## Memorandum

**To:** California Energy Commission  
CEC Docket No. 11-AFC-03, Quail Brush Power Generation Siting Case.  
**Attention:** Mark Hamblin and Eric Solorio

**Subject:** **Photo Survey of Visual Impacts**, and Visual Resources Comments, Proposed Quail Brush Power Plant, San Diego CA

**FIGURE 4.5-4**  
**Viewpoint 2: MTRP, Grasslands Section Existing Conditions (looking northeast)**

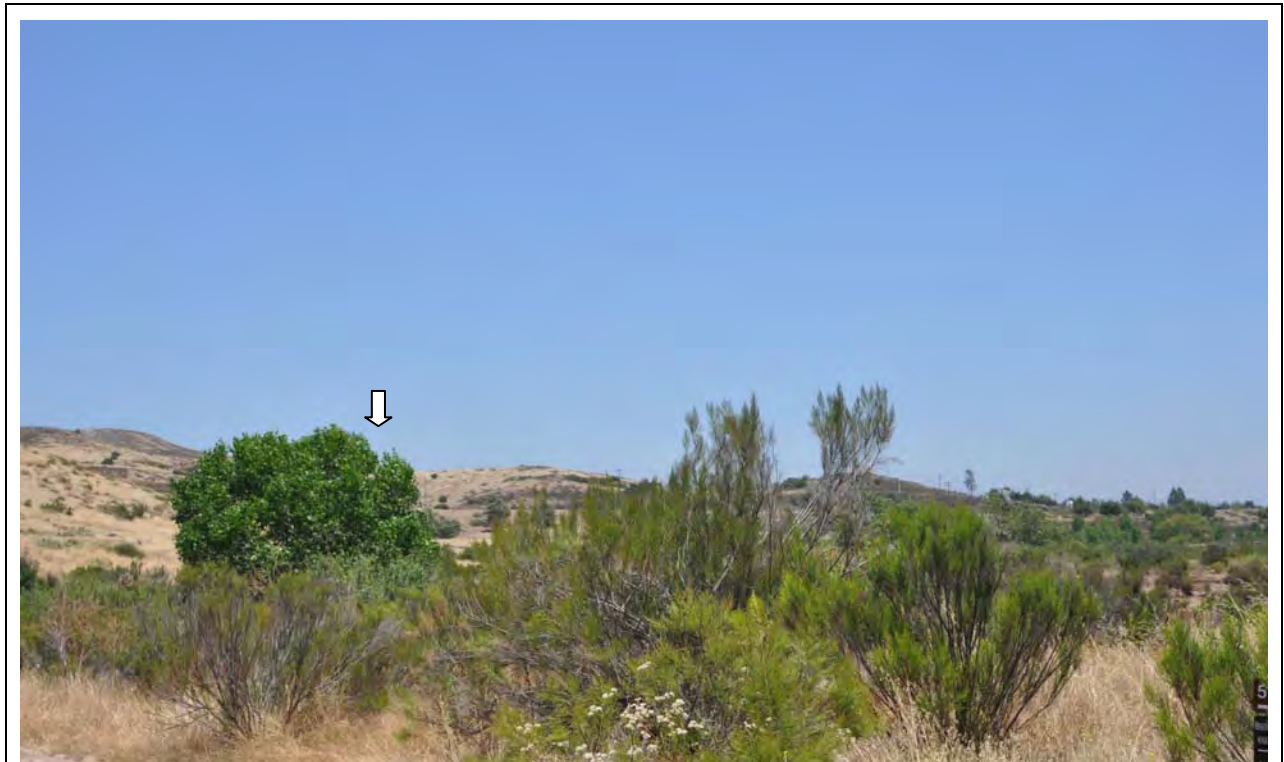
Viewpoint 2: MTRP, Grasslands Section – this photo misrepresents the grassland area of MTRP, which typically consists of open areas of native grasses, and which includes historical resources. Instead, the photo shows brush and trees near the San Diego River channel, and it was taken in such a manner that one of the few larger trees blocks the view to the proposed plant location. Table 4.5-1 states that project site visibility from Viewpoint 2 is “low;” although this is strictly correct for that photo, the photo fails to depict a typical grasslands view and therefore the stated site visibility from a typical grasslands location is incorrect.

Viewpoint 7, MTRP, Fortuna Mountain – the text states this photo “..represents a *common*, high-elevation view available to MTRP trail users in the vicinity of the plant site.” (italics added) and “The transmission lines and landfill draw attention away from much of the surrounding terrain and detract from the scenic quality.” Depending on location in the park, the powerlines and landfill do have some impact on scenic quality; however, the implication that Viewpoint 7 is typical or representative of high-elevation views is simply wrong. There is only one alignment of power lines through the park, and the photo location is directly adjacent to those power lines such that they dominate the view. This photo falsely conveys that the typical view from higher elevation points in the eastern part of the park are severely impacted by power lines. Conversely, many of the popular trails in the eastern portion of the park emanate from Father Junipero Serra Trail (which itself is very popular) and are nowhere near the existing power lines to the north.
